Application No. 09/938,947
Amendment and Response dated July 16, 2004
Reply to Office Action of March 16, 2004

REMARKS/ARGUMENTS

Fig. 9

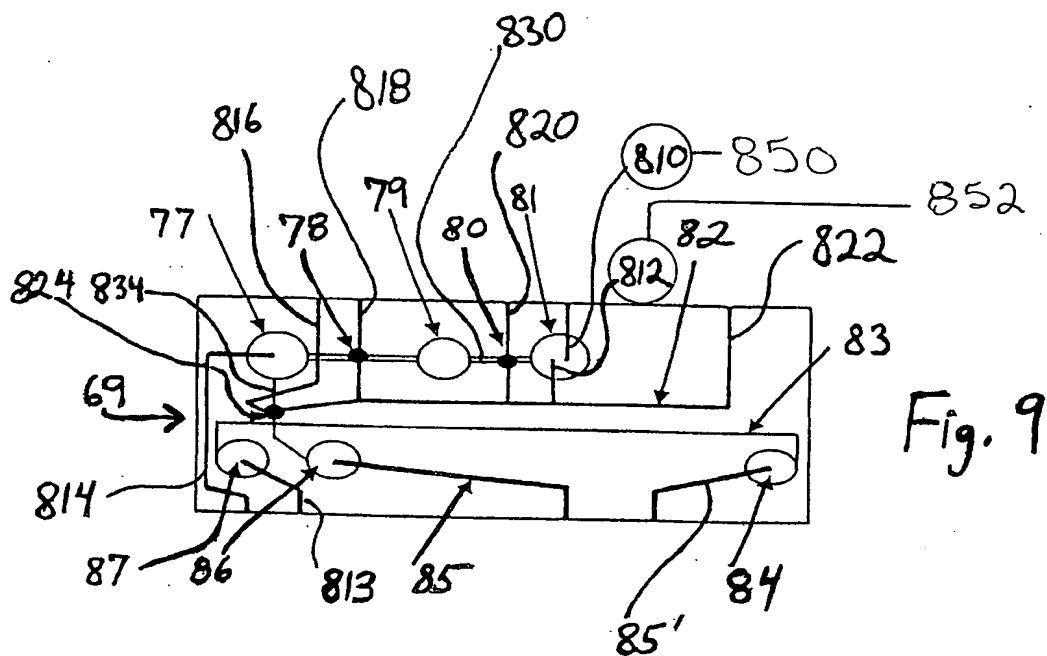
Fig. 9 has also been objected to by the Examiner for including duplicate reference signs **810** and **812** in the figure. Applicants have addressed this objection by a proposed drawing correction to change reference characters **810**, **812** in Fig. 9 to **850**, **852**, as described in the amended specification at page 36, line 2. Withdrawal of this objection to the drawings is respectfully requested.

The drawings have been objected to for failing to comply with 37 C.F.R. § 1.84(p)(4) because reference characters **810** and **812** have been used to designate two different features in the figures. Applicants have addressed this objection by redesignating **810** and **812** in Fig. 9 with new reference numbers **850** and **852**, respectively. Withdrawal of this objection to the drawings is respectfully requested.

Fig. 19

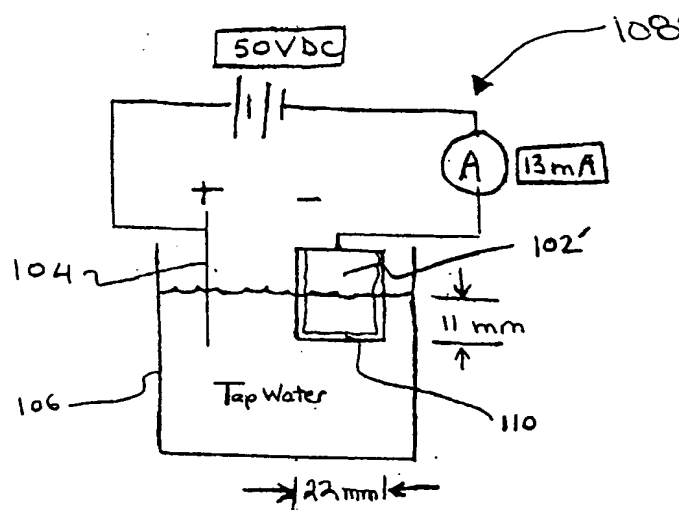
Fig. 19 has been objected to for including a reference sign **110** which is not mentioned in the specification. Applicants have addressed this objection by the above revision to the specification at page 48, line 7 to indicate that reference sign **110** is directed to an insulating border made of epoxy. No new matter has been added by this amendment to the specification. Withdrawal of the objection to Fig. 19 is requested.

The drawings have been objected to for failing to comply with 37 C.F.R. § 1.84(p)(5) because they do not include reference signs **802** and **108'**. Applicants have addressed the objection to reference sign **802** through the above amendments to the specification at pages 33 and 34. The objection to reference sign **108'** has been addressed by the correction to Fig. 19. Withdrawal of these objections is respectfully requested.
